SAIHAM KNIT COMPOSITE LTD. (Extension 2)

16 January 2025

2. Observations

Observation-1: Design report needs to be reviewed against lateral forces (Locker Building).

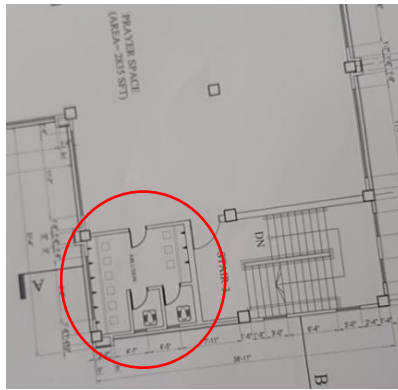
Description: The prepared design report needs to be reviewed against lateral forces. Submit the design report to the RSC for detailed review.

Observation-4: Inconsistency and lack of information in the design report.
(Printing Building, Knitting Building).

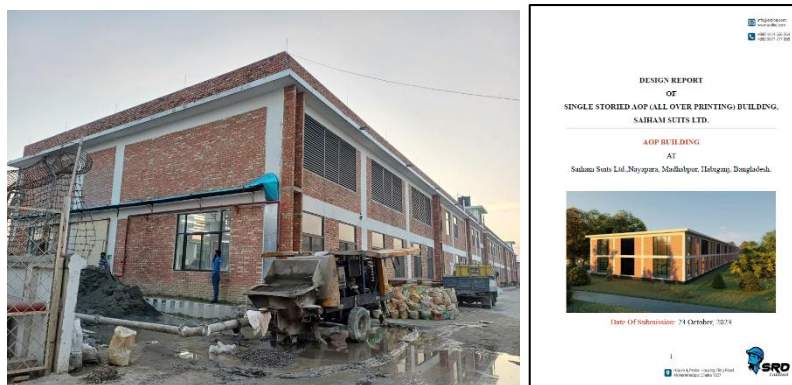
SMF detailing & structural irregularity checks were not incorporated in the provided design report.

Description: The building engineer has prepared the design report based on Special Reinforced Concrete Moment Frames (SMF). However, SMF detailing checks have not been addressed in the report as per BNBC 2020 Part VI, Section 8.3. The building engineer must incorporate the check in compliance with all SMF detailing requirements outlined in BNBC 2020 Sections 8.3.4, 8.3.5, 8.3.7, 8.3.8, and 8.3.11. The building engineer has not incorporated the horizontal and vertical irregularity checks. Additionally, the structure also features re-entrant corners therefore, all horizontal and vertical irregularity checks must be included in the report.

These checks should be verified and incorporated into the design report to ensure full alignment with the code provisions. Submit the revised design report to RSC for review.

Observation-5: Design report needs to be reviewed against lateral forces (AOP Building).

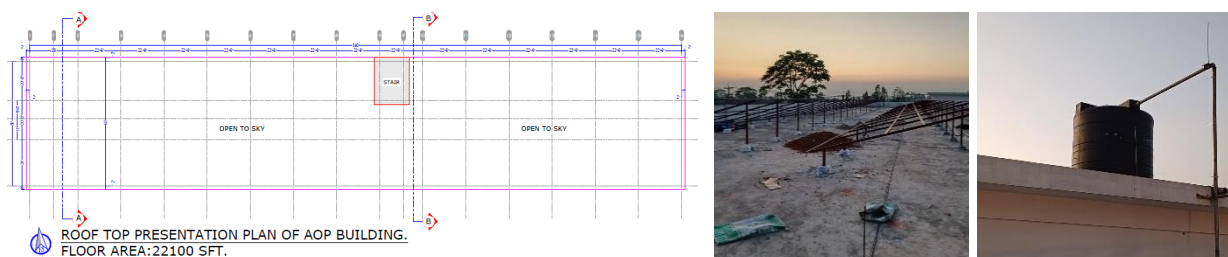
Description: The design report prepared needs to be reviewed against lateral forces. Submit the design report to the RSC for detailed review.

Observation-8: Design report needs to be reviewed against lateral forces (Yarn Warehouse).

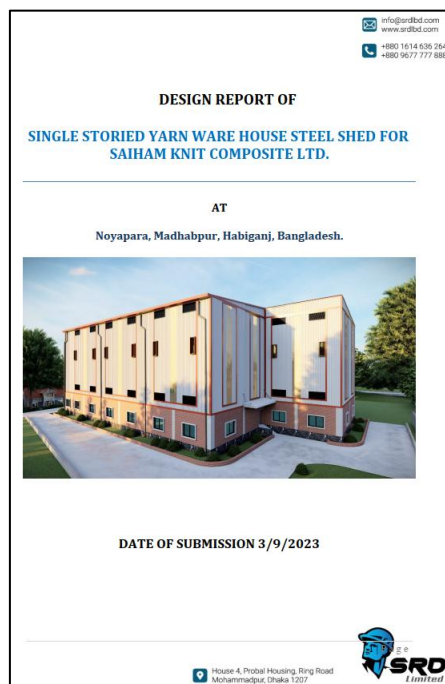
Description: The design report prepared needs to be reviewed against lateral forces. Submit the design report to the RSC for detailed review.

Observation-9: Disconnected roof bracing (Yarn Warehouse).

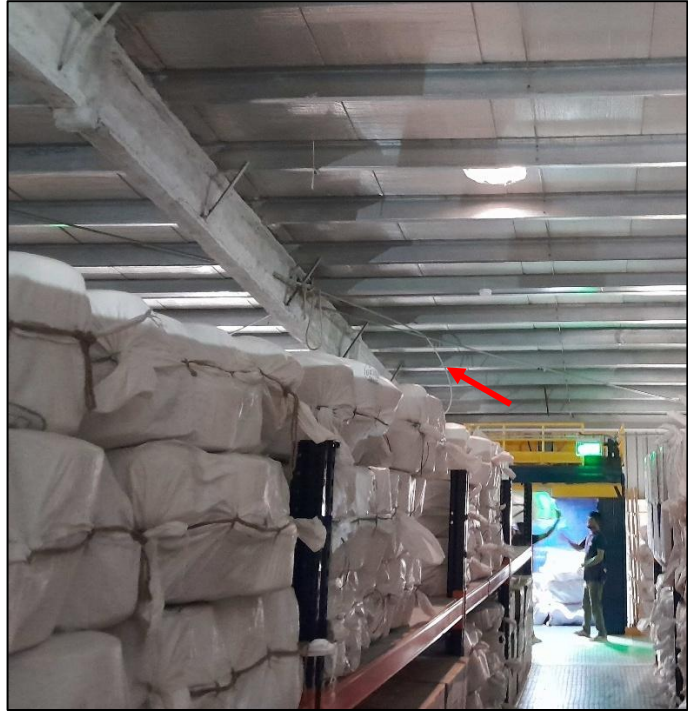
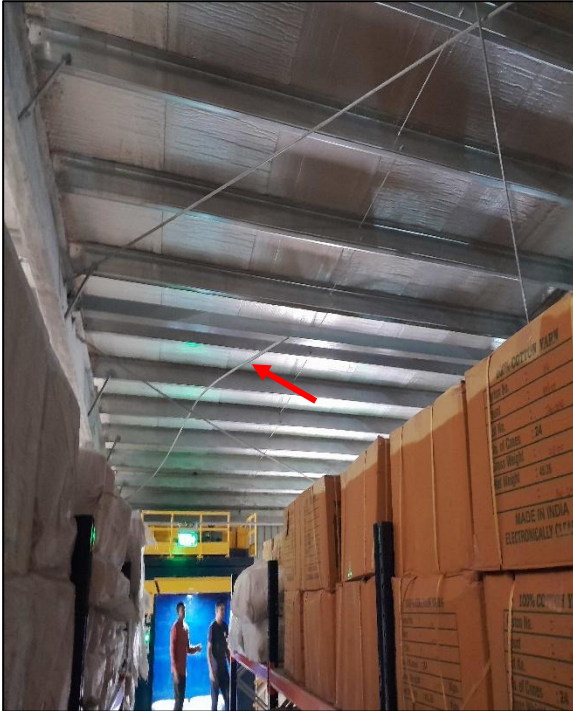
Description: During the inspection, disconnected roof bracings were observed at several locations. The factory is required to connect all the roof bracings appropriately.

Observation-13: Inconsistency and lack of information in the design report (Dyeing Building).

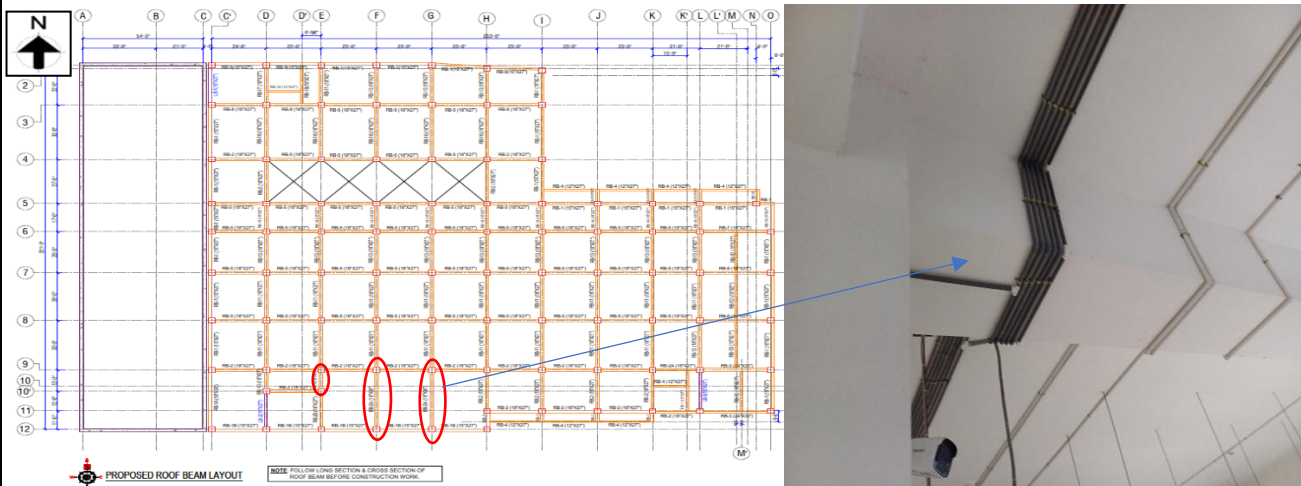
Torsional irregularity exists in the structure.

SMF detailing, beam adequacy, pile bearing capacity, structural irregularity etc. checks were not incorporated in the provided design report.

Description: The torsional irregularity exists in the structure. It shall be accounted as BNBC 2020 Part-VI Section 2.5.7.6.2. Also, the building engineer has prepared the design report based on Special Reinforced Concrete Moment Frames (SMF). However, SMF detailing checks have not been addressed in the report as per BNBC 2020 Part VI, Section 8.3. The building engineer must incorporate the check in compliance with all SMF detailing requirements outlined in BNBC 2020 Sections 8.3.4, 8.3.5, 8.3.7, 8.3.8, and 8.3.11. Additionally, the geotechnical investigation report does not recommend the $\phi 600$ pile capacity, and the pile bearing capacity check must be included in the design report. The structure also features re-entrant corners and diaphragm discontinuity; therefore, all horizontal and vertical irregularity checks must be included in the report. These checks should be verified and incorporated into the design report to ensure full alignment with the code provisions. Submit the revised design report to RSC for review.

Observation-14: Discrepancy and lack of information in provided drawing (Dyeing Building).

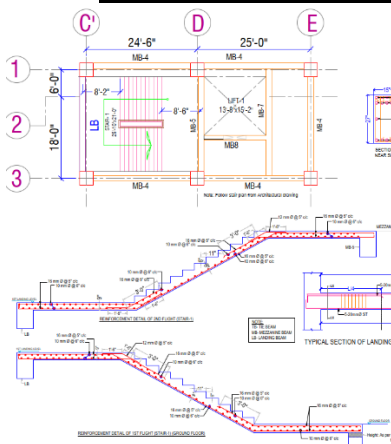
Mentioned roof beam width 600mm instead of 450mm as per the provided drawing.

Description: During the inspection, discrepancies and lack of information were observed between the provided drawing and on-site conditions. The building engineer is required to survey the whole structure and update the drawing reflecting actual on-site condition.

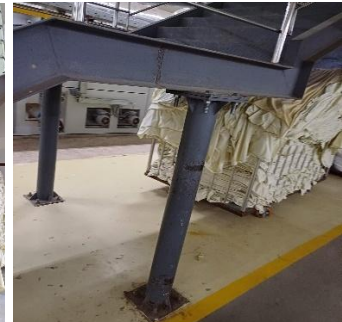
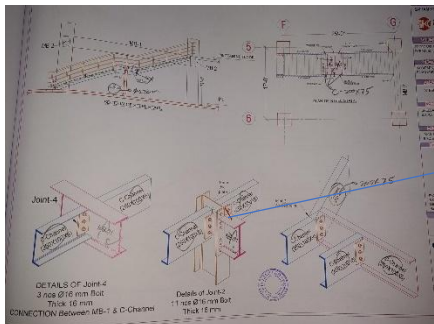
14 no's stair tread found instead of 10 no's in the one flight. Also, mentioned tread riser size mismatching as mentioned in the drawing.

Pipe section and c-channel found instead of I-section. Also, connection detail mismatches.

Observation-17: Trolley impact on column surface (Dyeing Building).

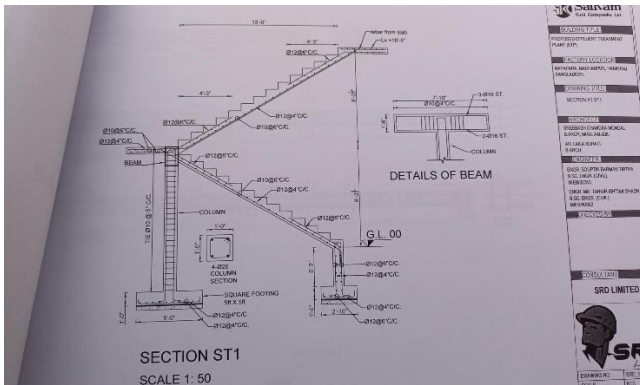
Description: The cover of floor columns was damaged due to trolley impact. The building engineer is required to provide column/wall guard to protect from trolley impact.

Observation-19: Mismatch and lack of information in provided drawing (ETP-3).

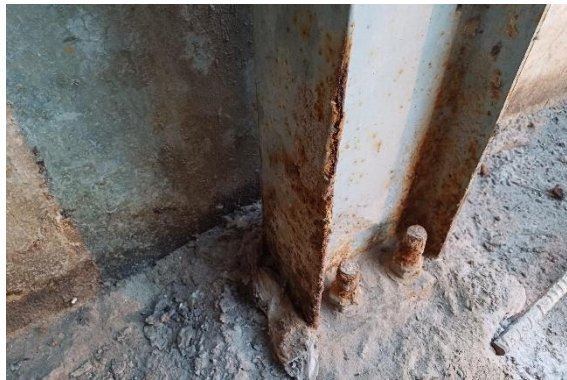
Steel stair found instead of RC stair as per the provided drawing

ETP roof top lab room & steel roof structural details were not shown in the provided drawing

Description: During the inspection, discrepancies and lack of information were observed between the provided drawing and on-site conditions. The building engineer is required to survey the whole structure and update the drawing reflecting actual on-site condition.

Observation-23: Lack of information in provided drawing (Hydrogen Peroxide Building).

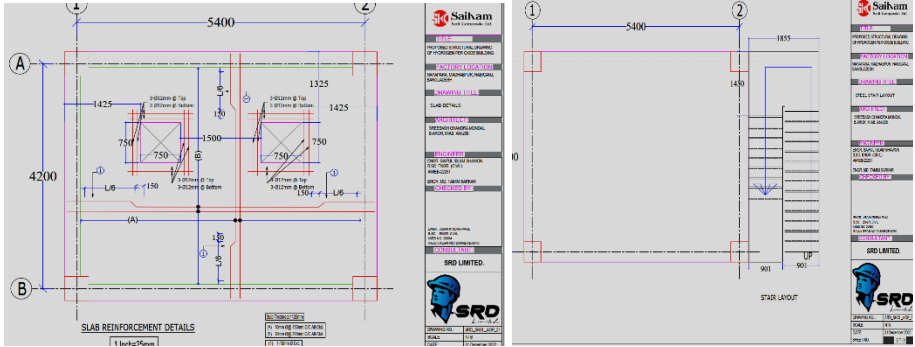
Cantilever slab on peripheries has not been shown, and the proposed stair has not been constructed.

Description: During the inspection, lack of information was observed between the provided drawing and on-site conditions. The building engineer is required to survey the whole structure and prepare as-built drawing reflecting actual on-site condition.
